Private Fuel Storage, LLC

**DATA NEEDED FOR NRC REVIEW OF LICENSE AMENDMENT # 22
DOCKET NO. 72-22/TAC NO. L22462
PRIVATE FUEL STORAGE FACILITY
PRIVATE FUEL STORAGE L.L.C.**

Enclosure 1

Response to NRC letter dated May 7, 2001

Figure SHA01-1 Fractile hazard curves for PGA

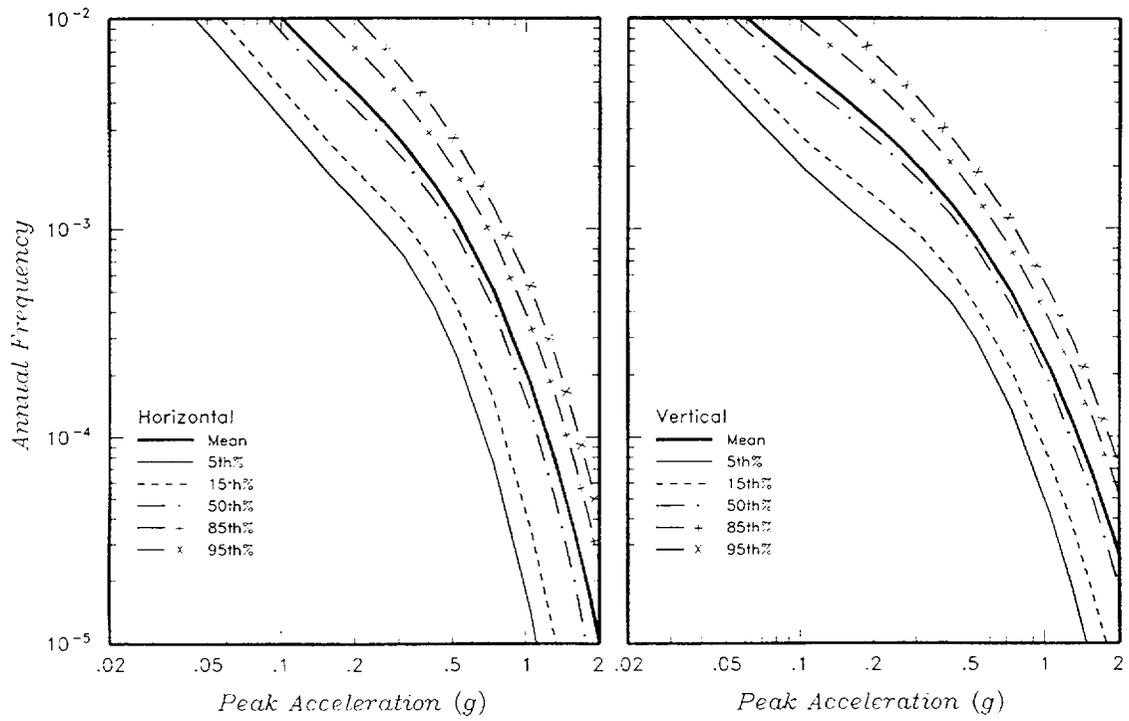
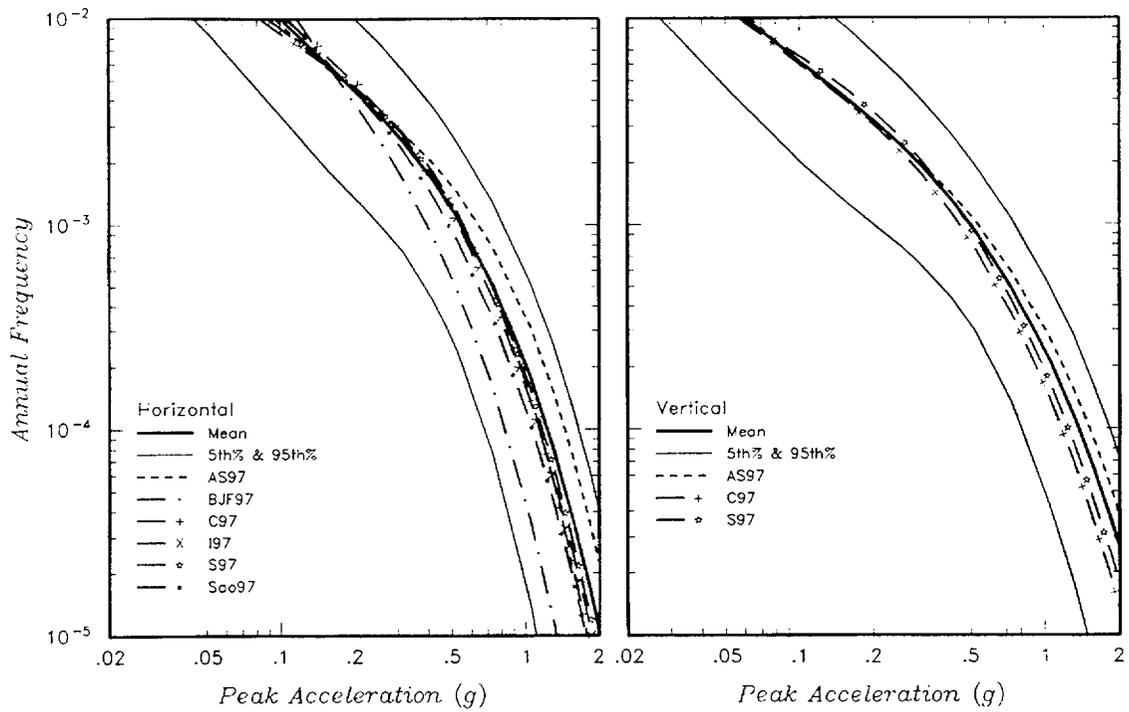
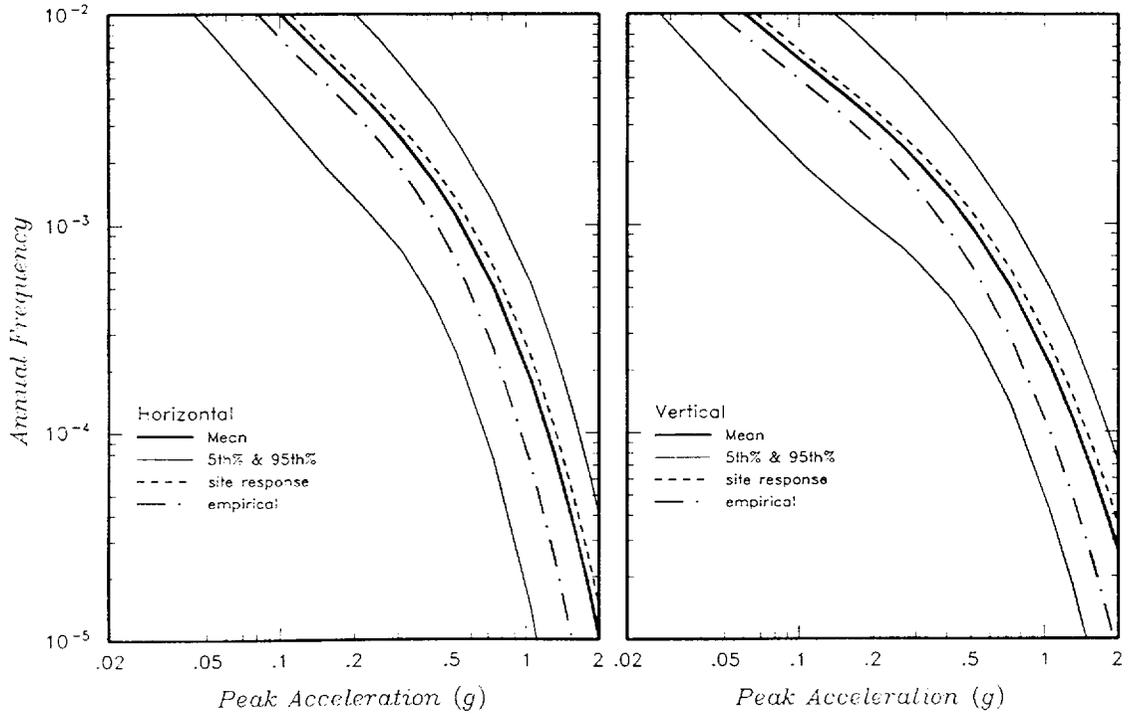
- 1. Deaggregated hazard curves (mean and fractiles) for horizontal and vertical ground motion for each attenuation and site response model at all 16 frequencies.**

The following series of figures illustrates the results in terms of the fractile hazard curves over all uncertainties and the condition mean hazard curves for specific cases. The first figure in each set of three shows the mean and fractile hazard curves over all uncertainties. The second figure shows the mean and 5th and 95th-percentile fractile hazard curves over all uncertainties and the conditional mean hazard curves for each attenuation relationship. The third figure shows the mean and 5th and 95th-percentile fractile hazard curves over all uncertainties and the conditional mean hazard curves for the two site factors based on empirical and site response approaches.

Figure SHA05d-1 Comparison of 2000-year equal hazard response spectra (5% damping) for generic California rock and deep soil site conditions (no site adjustment factors applied).

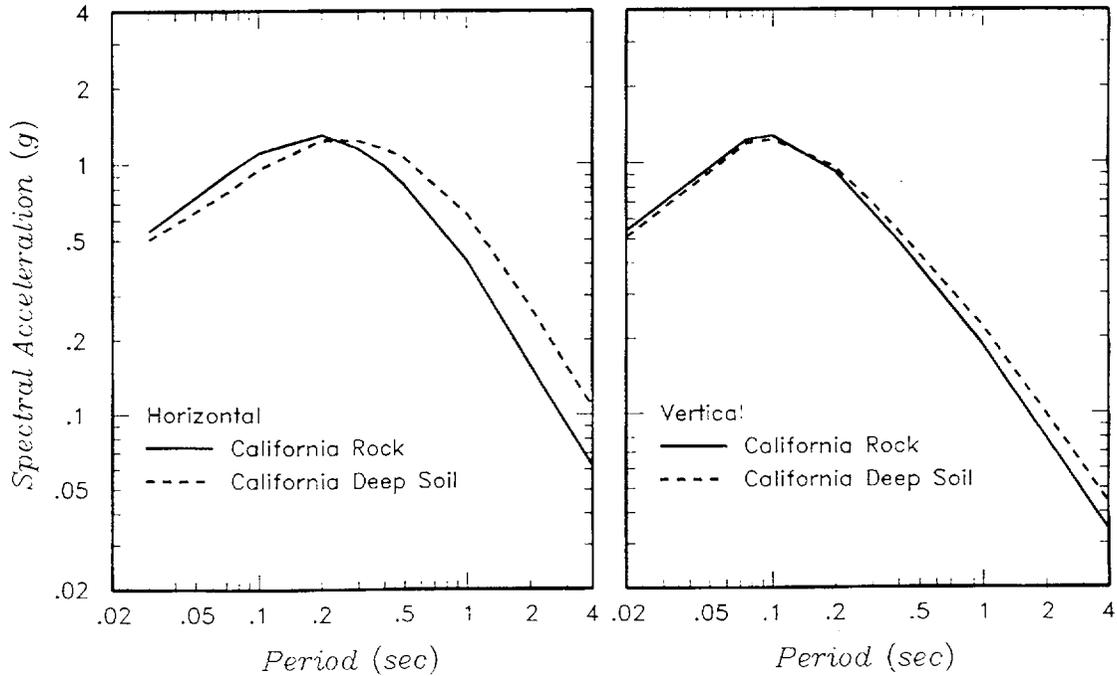
The change from soil to rock as the reference site condition was made because a review of the updated soil data indicates that the site velocity profile is closer to that for a generic rock site representative of the data used in the California rock empirical models and because use of rock relationships does not require the assumption that the weights developed by the Yucca Mountain Ground Motion Expert Panel for rock attenuation relationships also apply to the companion soil attenuation relationships.

The effect of using rock attenuation relationships rather than soil attenuation relationships is illustrated by the following sensitivity analysis. Seismic hazard analyses were performed using the suite of rock and soil attenuation relationships without modification for local site conditions. The hazard results were used to construct 2,000-year return period response spectra for California rock and deep soil site conditions. These spectra are compared on Figure SHA05d-1. The change from soil to rock site motions results in

a slight increase in the high-frequency portion of the spectra and a decrease in the low frequency portion of the spectra.

Figure SHA05e-1 Effect of weights assigned to site response factors on 2000-year equal hazard response spectra (5% damping)

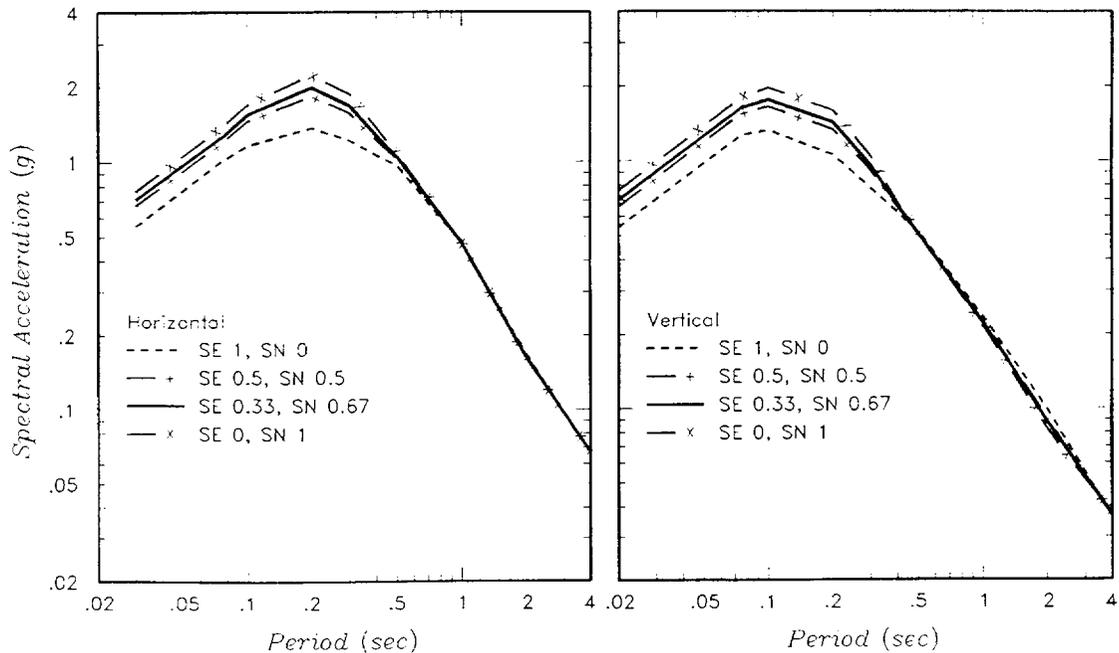
- 5. Complete description of the site soil characterization update including:**
- a. site data,
 - b. discussion of the site investigation timeline,
 - c. complete description of the evolution of the site model, noting parameters that have remained constant as well as those that have changes,
 - d. suite of sensitivity results that show the ramifications of changing from a "soil" model to a "rock" model,
 - e. sensitivity results to demonstrate the sensitivity (or insensitivity) of the weighting factor (empirical vs. model).

As described in Appendix F of the revised seismic hazard analysis report, two alternative approaches were used to develop site adjustment factors to modify California rock site attenuation relationships to the site conditions at the Skull Valley PFSF site. One approach was based on relative site response analyses (designated SN in this response) and one was based on empirical strong motion data (designated SE in this response). The site hazard was computed assigning a weight of 0.67 to the site response approach and a weight of 0.33 to the empirical approach. To examine the sensitivity of the results to these weighting factors, the hazard analyses were repeated using a range of weighting alternatives. The following table lists the resulting 2,000-year return period equal-hazard response spectral accelerations (5% damping). These spectra are shown on Figure SHA05e-1.

The design ground motion spectra are sensitive to the relative weights assigned to the empirical and site response site adjustment factors for spectral periods less than about 0.5 seconds (spectral frequencies greater than about 2 Hz).

Figure SHA08-11 Comparison of relative site response spectral ratios for the base case and alternative shear wave velocity profiles

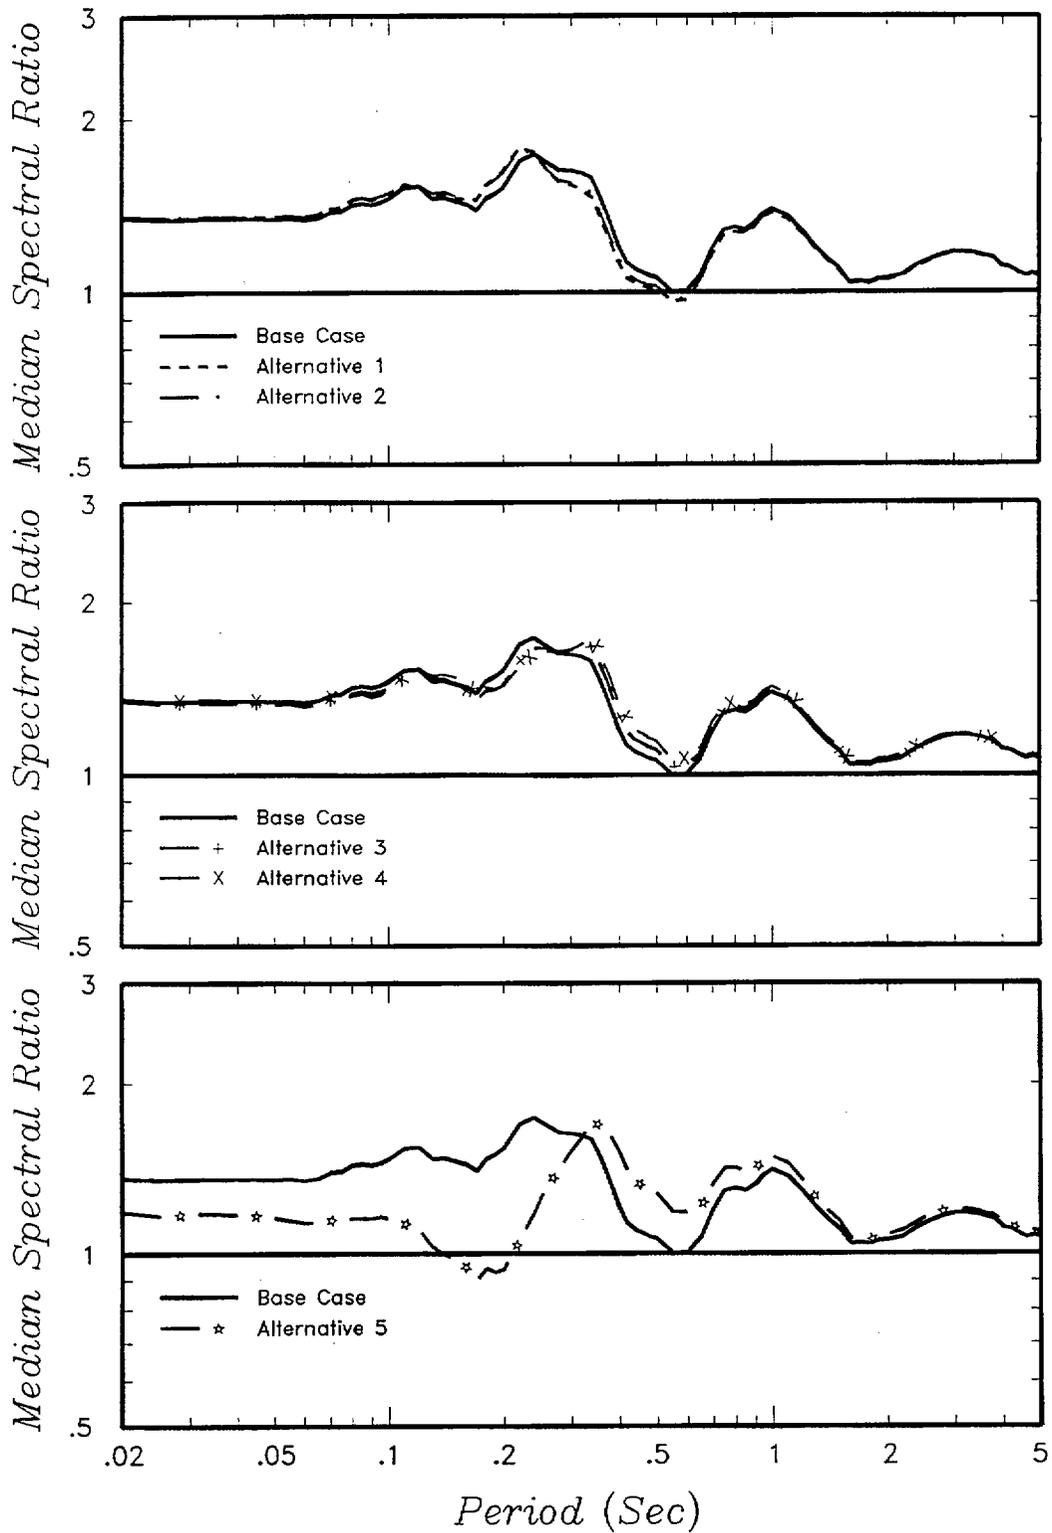
- 8. More site specific data (i.e., beyond the one existing deep well) for the soil between 30 ft and the Tertiary strata or provide an analysis that shows that the applicant has captured the uncertainty of the soil properties sufficiently such that any new information will not again significantly change the ground motions (i.e., sensitivity study of the site response model that would incorporate the variability of the soil parameters expected for this site).**

Alternative Profiles 1 through 4 are used in sensitivity analyses to assess the impact of alternative interpretations of the detailed velocity variation with depth below 30 feet on the relative site response analysis. For each average profile, 30 random velocity profiles were generated using the approach outlined in Appendix F of Geomatrix (2001a). These profiles are shown on Figures SHA08-5 through SHA08-9. A fifth alternative profile was defined in order to compare the importance of the velocity profile details in the upper 30 feet to site response to the importance of the velocity profile details below 30 feet. (This alternative used the same velocity profile as the base case for depths below 50 feet.) Alternative Profile 5 replaces the shallow portion of the base case profile with a uniform velocity of 850 ft/sec, the average velocity for the top 50 feet of the base case profile. Figure SHA08-10 shows the 30 random profiles generated using the Alternative Profile 5 average velocity.

For each of the six analysis cases, the base case and the five alternative profiles, 240 site response analyses were conducted using the 24 input time histories developed in Appendix F of Geomatrix (2001a). The response spectra for the computed surface motions were divided by the corresponding spectra for a WUS rock site. The median (mean-log) of the 240 spectral ratios was then computed. Figure SHA08-11 compares these spectral ratios. The spectral ratios obtained using Alternative Profiles 1 through 4 show only minor differences from the base case results. Alternative 5 results in a large change in the computed spectral ratios. These results indicate that the details of the velocity profile in the upper 30 feet of soil (where the lowest velocities are experienced) are much more significant to the computation of relative site response than those below 30 feet (where the higher velocities are experienced), and that for levels below 50 feet the details of the velocity distribution assumed have little effect on the predicted relative site response.
